LOCATION 35 Robin St

Your application to install a 26.5'x48' manufactured home has been reviewed and a permit is herewith issued subject to the following requirements:

You are hereby notified that a "STOP WORK ORDER" has been issued on construction at the above referenced site. The existing foundation does not comply with plans submitted as the basis for building permit #92-4123 issued on September 16, 1992 by the City of Portland. This is in violation of Section 113.3 of the BOCA Building Code.

Your application to permit amendment #2 for change of bulkhead location and install egress window at 35 Robin St. has been reviewed, and a permit is herewith issued subject to the following requirements:

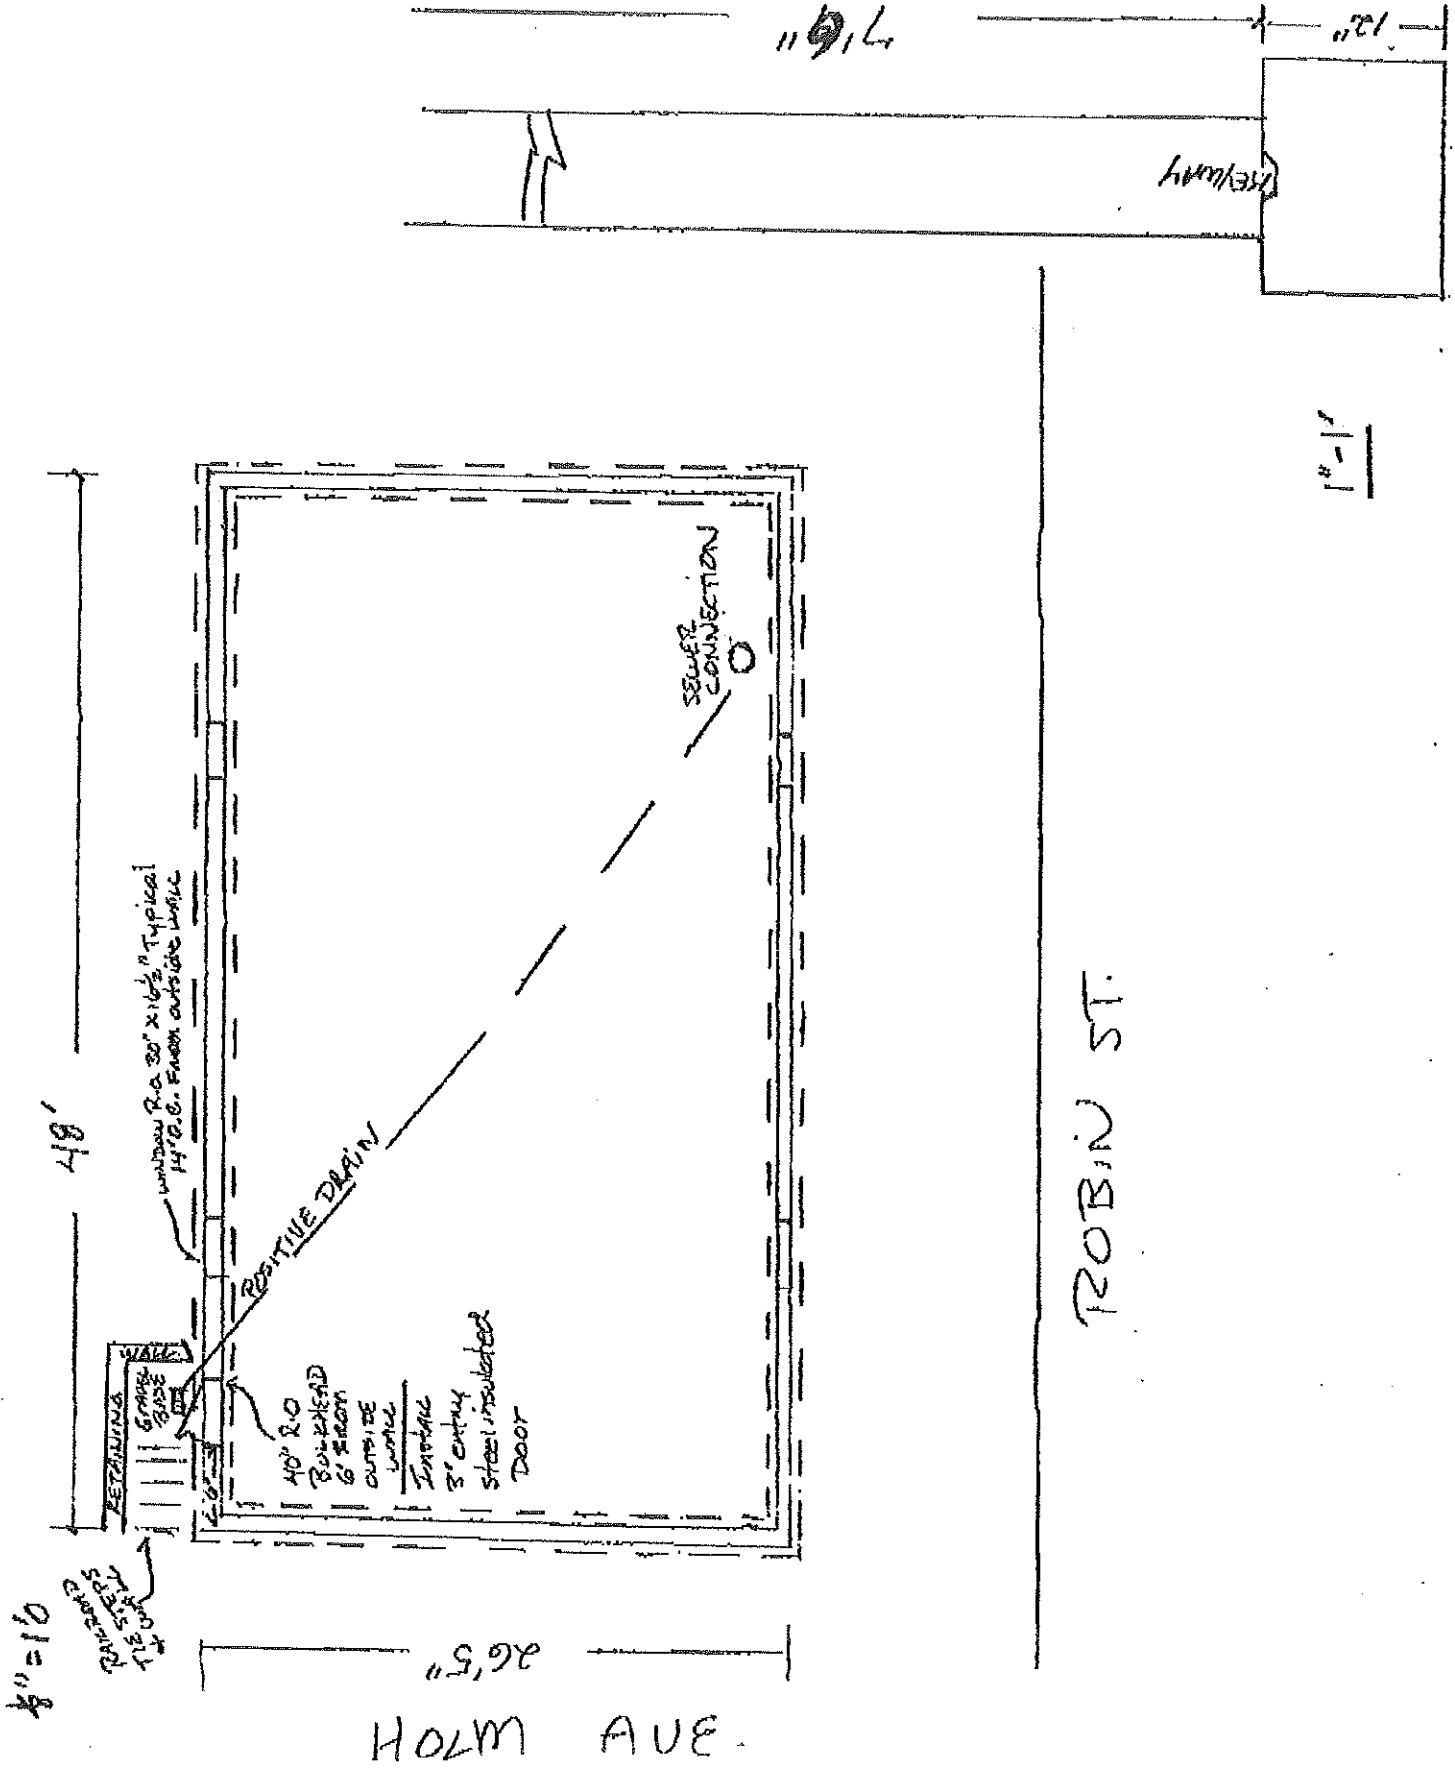
change location of bulkhead - from rear to right
